Project	IEEE 802.16 Broadband Wireless Access Working Group <http://ieee802.org/16>	
Title	Comments on MS ranging and network entry in transparent RS systems	
Date Submitted	2007-09-09	
Source(s)	Kanchei (Ken) Loa, Yi-Hsueh Tsai, Yung-Ting Lee, Hua-Chiang Yin, Shiann-Tsong Sheu, Youn-Tai Lee,	Voice: +886-2-27399616 Fax: +886-2-23782328 loa@iii.org.tw
	Institute for Information Industry 8F, No. 218, Sec. 2, Dunhua S. Rd., Taipei City 106, Taiwan	
	[add other co-authors here]	
Re:	IEEE 802.16j-07/043: “IEEE 802.16 Working Group Working Group Letter Ballot #28”	
Abstract	This contribution proposes to correct and merge the paragraphs in subclauses 6.3.9.16.1, 6.3.10.3.4.1 and 6.3.10.3.4.3.	
Purpose	Text proposal for 802.16j Draft Document.	
Notice	<i>This document does not represent the agreed views of the IEEE 802.16 Working Group or any of its subgroups. It represents only the views of the participants listed in the “Source(s)” field above. It is offered as a basis for discussion. It is not binding on the contributor(s), who reserve(s) the right to add, amend or withdraw material contained herein.</i>

Comments on MS ranging and network entry in transparent mode

Figure 1 Response latencies for using RNG-REQ and MR_Code-REP

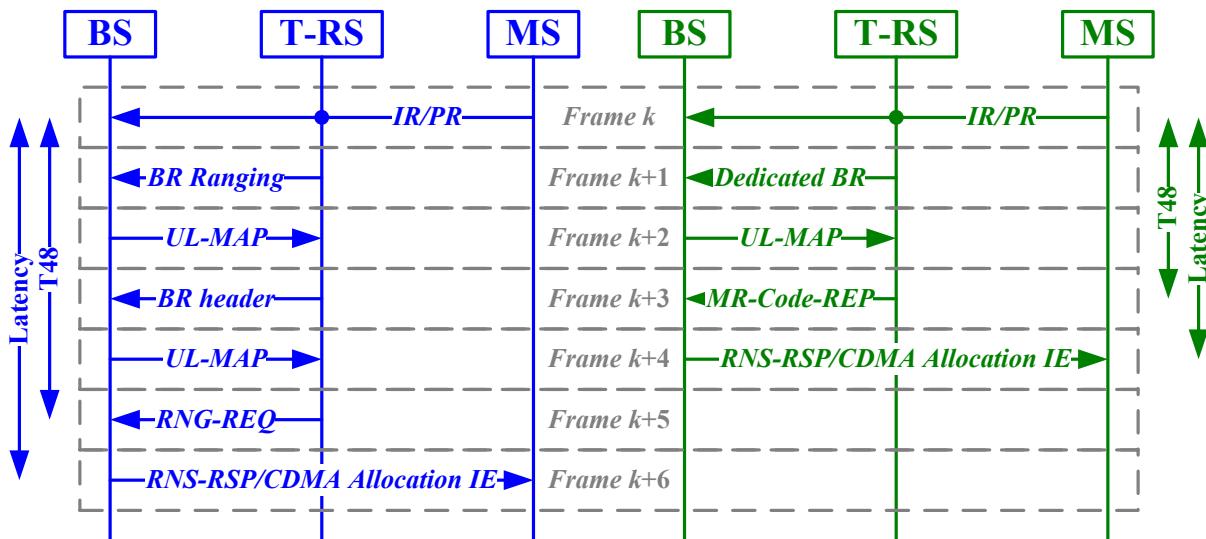
The response latency and message size of using RNG-REQ and MR_Code-REP are described in Figure 1 and Table 1, respectively. In the left side of Figure 1, the value of T48 must be at least 5 frames (25 ms for 5-ms frame). The MR-BS should allocate at least 41 bytes for RS sending RNG-REQ message and will send RNG-RSP (or CDMA allocation IE) at the 6th frame after MS sends initial ranging code. Thus, the minimum latency of initial or periodic ranging is 30 ms for 5-ms frame.

In the right side of Figure 1, the value of T48 must be at least 3 frames (15 ms for 5-ms frame). MR-BS should allocate at least 26 bytes for RS sending MR-Code-REP message and will send RNG-RSP (or CDMA allocation IE) at the 4th frame after MS sends initial ranging code. Thus, the minimum latency of initial or periodic ranging is 20 ms for 5-ms frame. In summary, response latency and message size for using MR_Code-REP are less than those for using RNG-REQ.

Figure xxx-a—Handling CDMA ranging code at a transparent RS

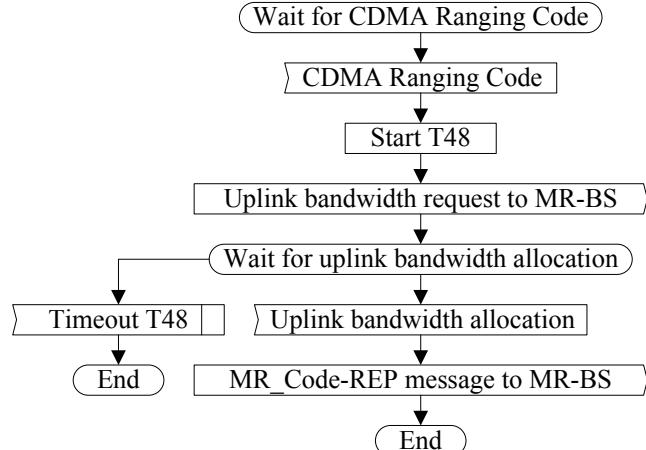
[Merge Figure 95a with Figure 108a and Figure 108h, and move it to 6.3.10.3.6.1 as following indicated:]

Figure xxx-b—Handling CDMA ranging code in transparent mode at MR-BS

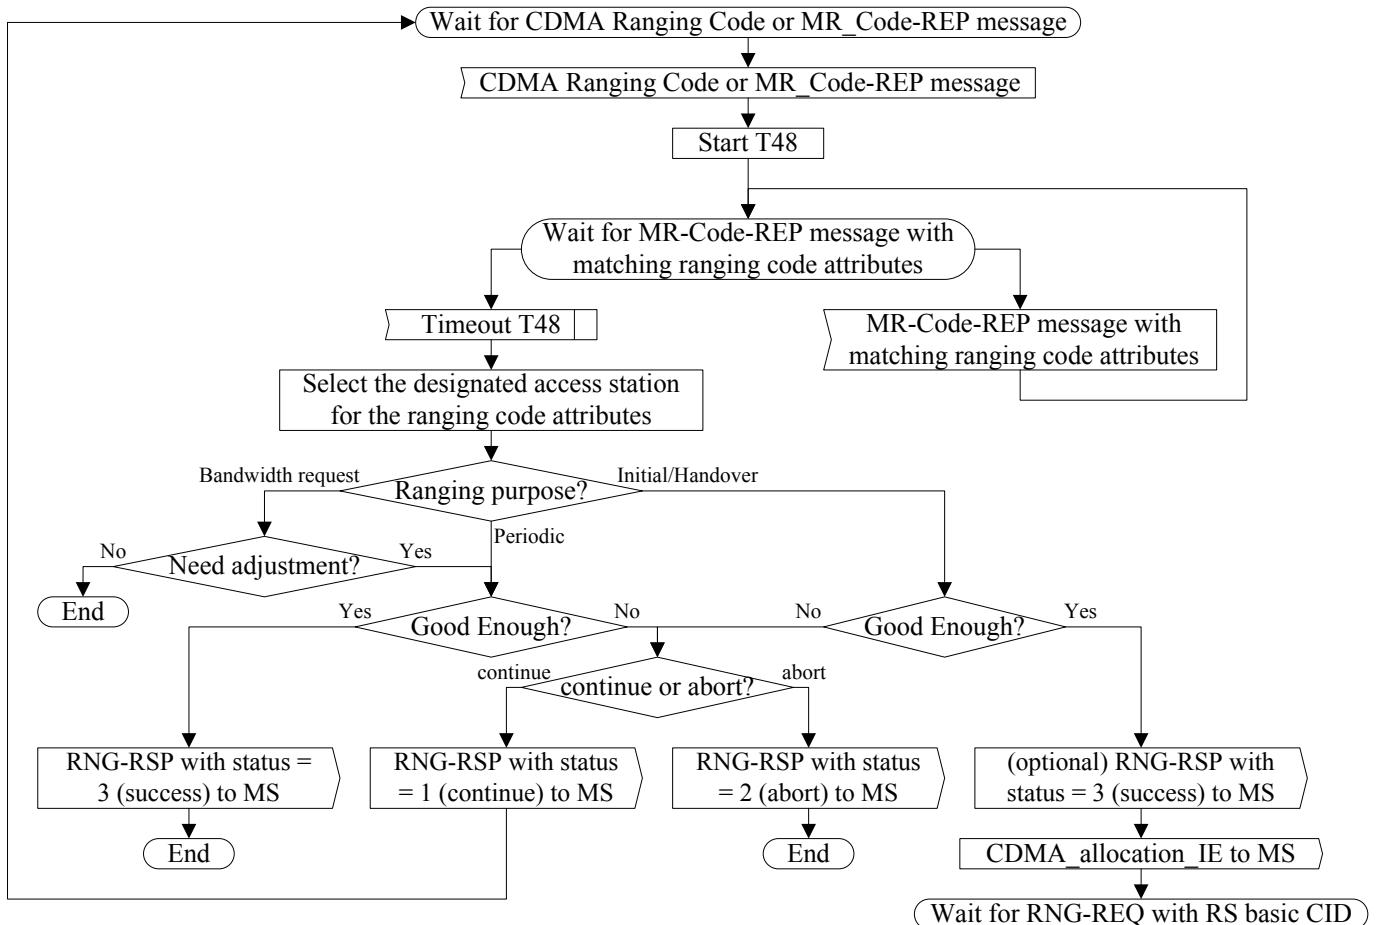
[Merge Figure 95c with Figure 108b and Figure 108i and move it to 6.3.10.3.6.1 as following indicated:]
